GENERAL ELECTRIC

Subject: Elec-Trak E-20

To: All Elec-Trak Dealers (Supersedes issue dated May 21, 1971)

The E-20 model of the Elec-Trak tractor is designed to have more power, performance and convenience than the other models. During the first few weeks of production, tractors were not built as intended, and require a few wire changes to give the expected performance. Each dealer who has received any E-20 model tractor should read this letter carefully to determine if modifications are necessary to units sold or in his inventory. Involved in this modification are:

Figure 1. Lower Control Panel

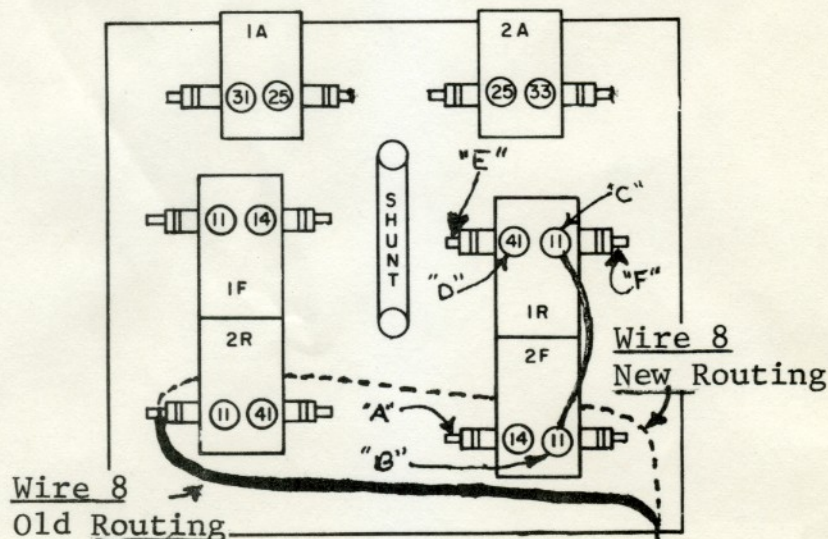
1. Identify heavy wire #8 connected to the left side of 2R contactor (See Figure 1).

1. Identify wire #6-01-6 (14 gauge) connected to the left side of 2F contactor (See "A" of Figure 1).
2. Cut this wire as close to its terminal as possible and strip wire and crimp on a new ring terminal suitable for a 14 AWG wire and a #10 stud. (Part identification number 34123 in your Wire Terminal Kit.)
3. Add this wire to the right coil stud of 2F contactor which presently has a wire coded #11 connected to it. (See point "B" in Figure 1.)
4. Check to see that jumper wire #11 is connected between points "B" and "C" as shown in Figure 1. If it is found to terminate at point "D" make the correction as required.
5. Mask wire code 6-01-6 with tape or other suitable means and renumber this wire "11".
6. Renumber the other end of wire 6-01-6 in the same fashion. This end is connected to 3A contactor coil which is located on the upper control panel just above 2A contactor.

4. Install wire number 60 (supplied) on pad 7 of card No. 3 and terminate its other end on the left side of 1R contactor, point E in Figure 1.
5. Install wire number 24 (supplied) on pad 1 of card No. 3 and terminate its other end on the right side of 1R contactor, point F in Figure 1.

2. Remove wire #8 and re-route it behind 2F and 2R contactors making sure it cannot touch the shunt.
3. Reconnect wire at its original connection point on 2R contactor.
